4. Thompson's Point

4.I. Report

4.VIII. Subdivision - Plans (1 Of 6)

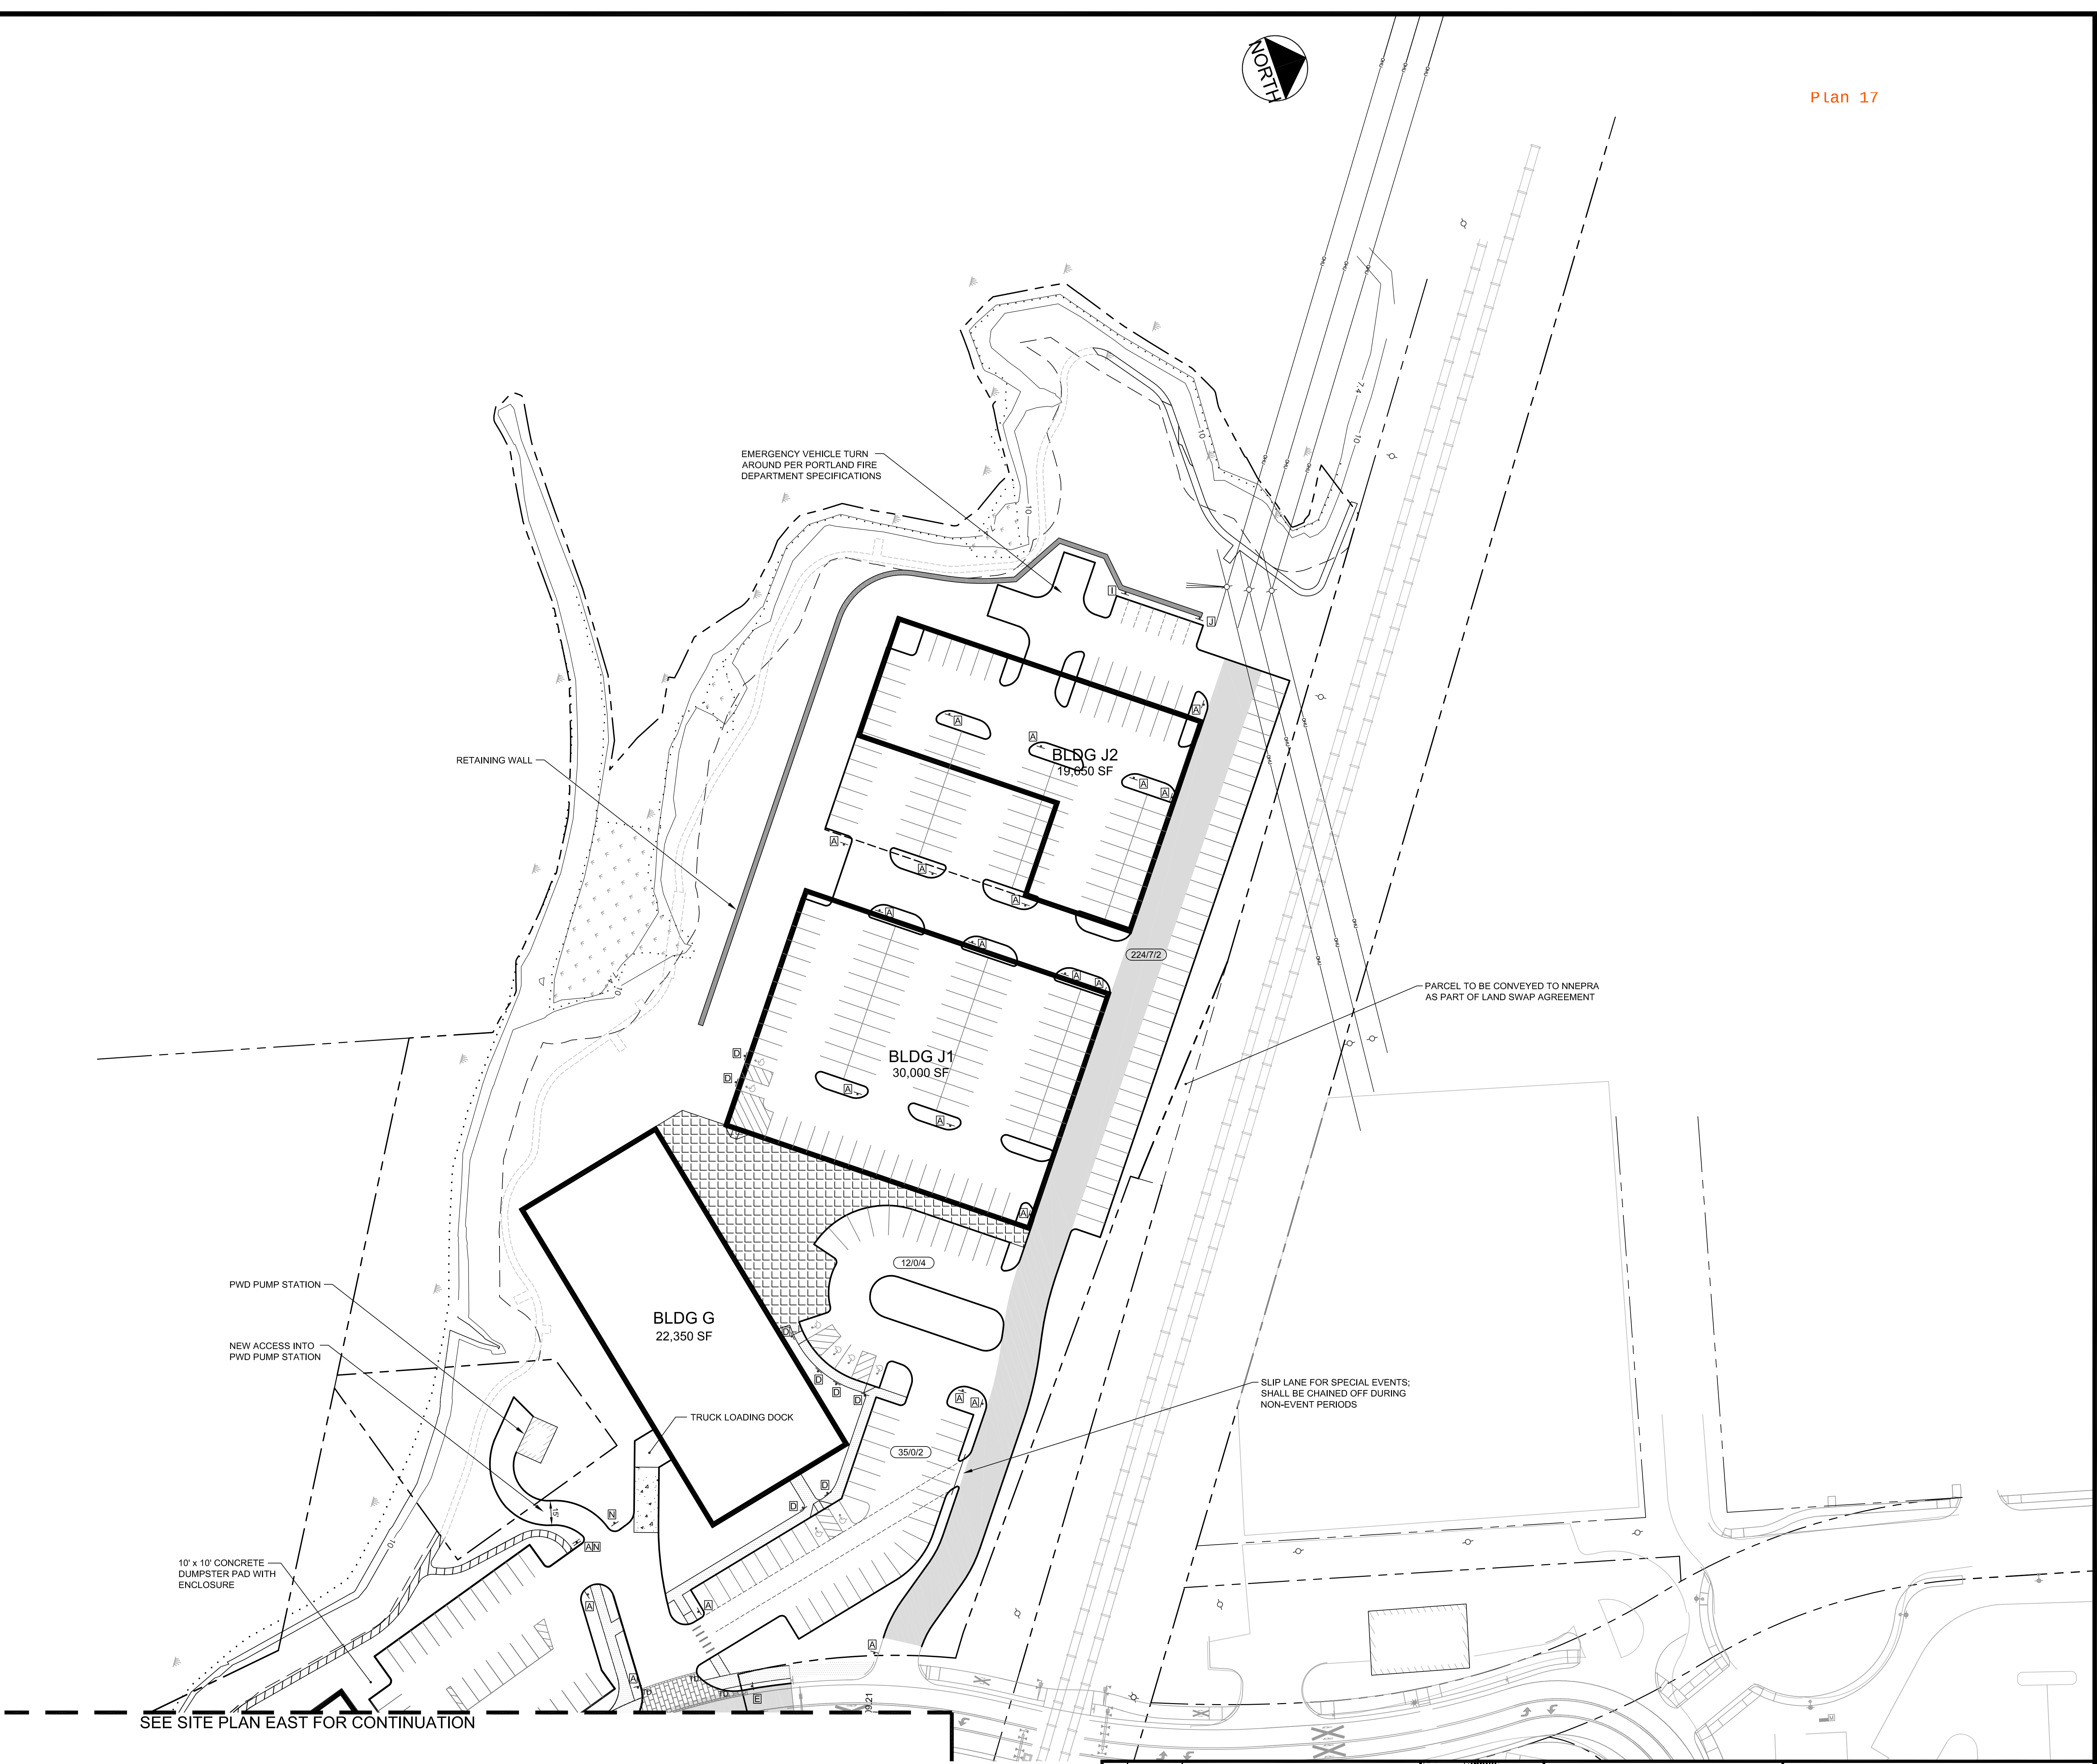
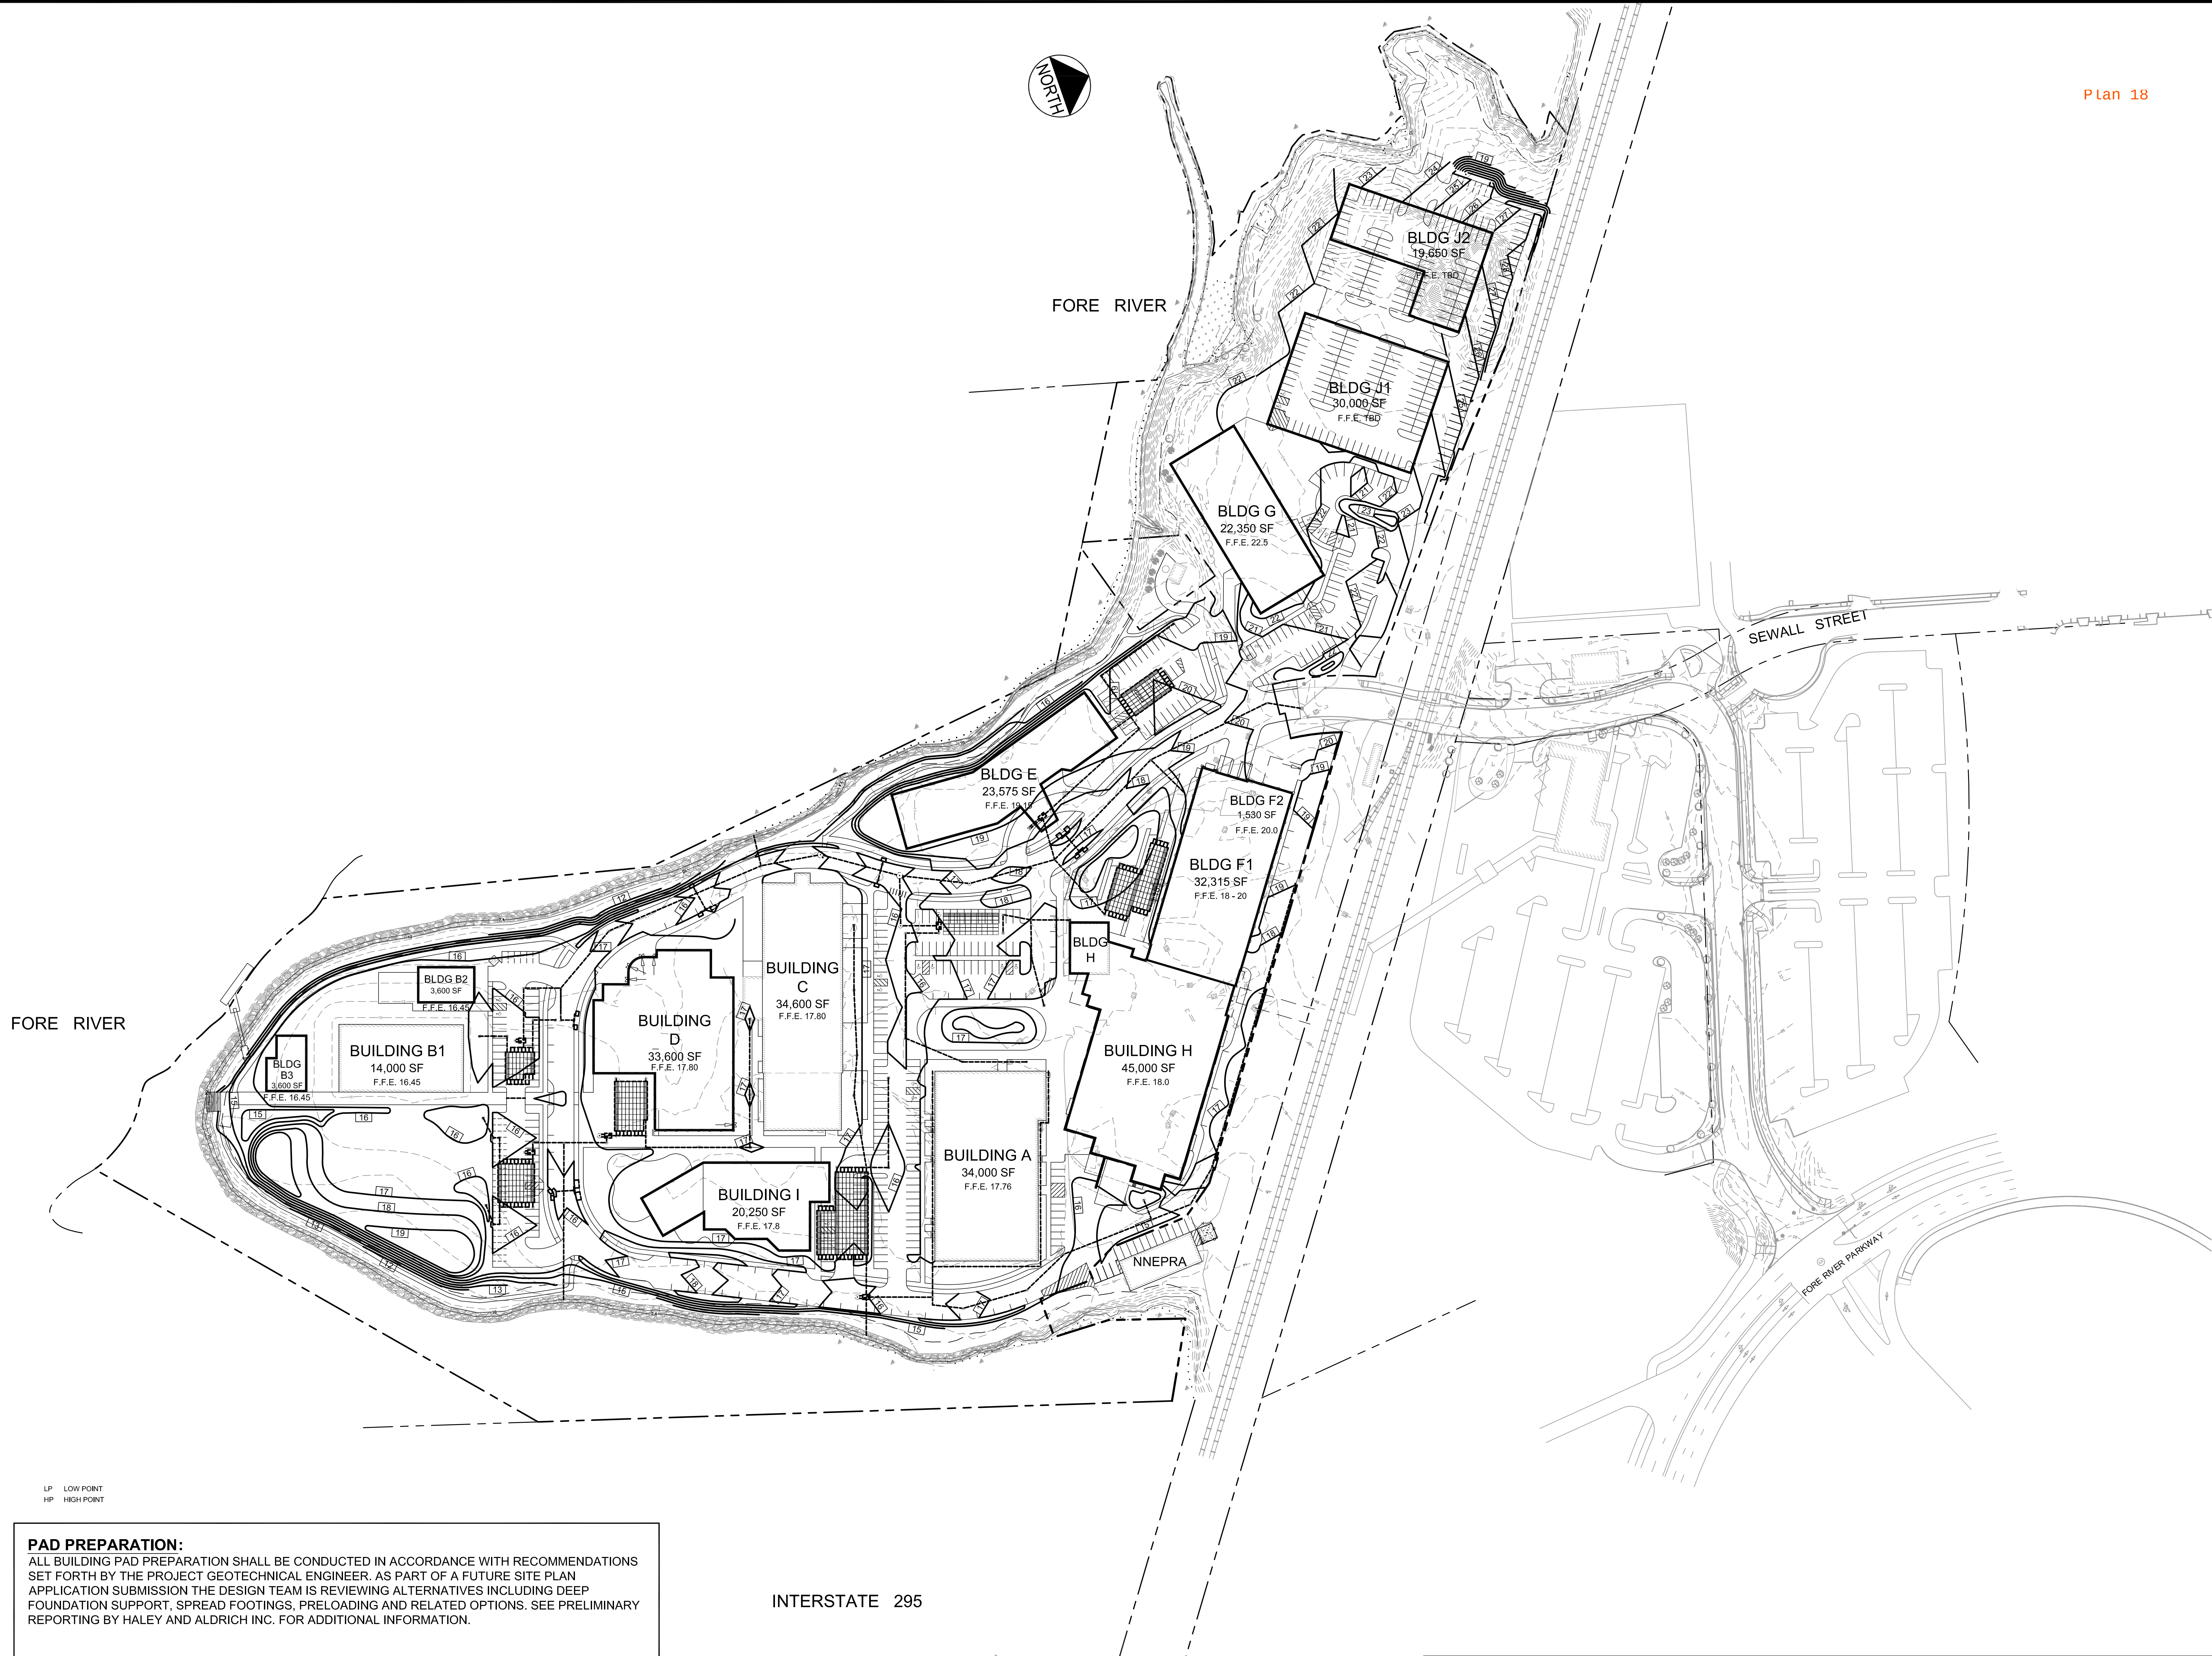
- Figure I-2. A requirement for continuous sidewalks on both sides of the collector road. There is a sidewalk planned for full length of the western side of the road, and a facing sidewalk that begins partway in to the first lot on the eastern side (suburban propane/Lots 14 & 15/location of Building F1/H on the overall site plan). The Level III site plan does not include the eastern sidewalk. Mr. Errico's comments: *The current Level III Site Plan for the Brick North/South phase does not include a sidewalk on the east side of Thompson's Point Road Extension. I support a waiver for building this sidewalk under this phase with the condition that the applicant will be responsible for construction of a sidewalk (and any necessary improvements to the Thompson's Point Road Extension) during the construction of Building H/F1, as depicted on the overall site plan.*

- Figure I-2. A requirement for a minimum roadway width of 40 feet for collector roads. The road design shows a range of 30-39 feet. Mr. Errico notes in his comments that he is comfortable with the proposed roadway cross-section.

- Figure I-2. Requirement for a minimum esplanade width of 5 feet for collector roads. Plan depicts a 4 foot esplanade.

2. The applicant shall provide a full construction management plan for review and approval by the Public Works Department.
4. Sidewalks and Road Improvements: At the time a Site Plan application is submitted for Buildings F1/H (or alternate Level III proposal for Lots 14 & 15 as depicted on Sheet C-2.0, *Subdivision Plan*), the portion of roadway included in Sheet C-3.0, *Site Layout Plan*, including the easterly sidewalk and all remaining road improvements, shall include provisions for conformity with the road design depicted on Sheet C-3.0, *Overall Site Plan*.
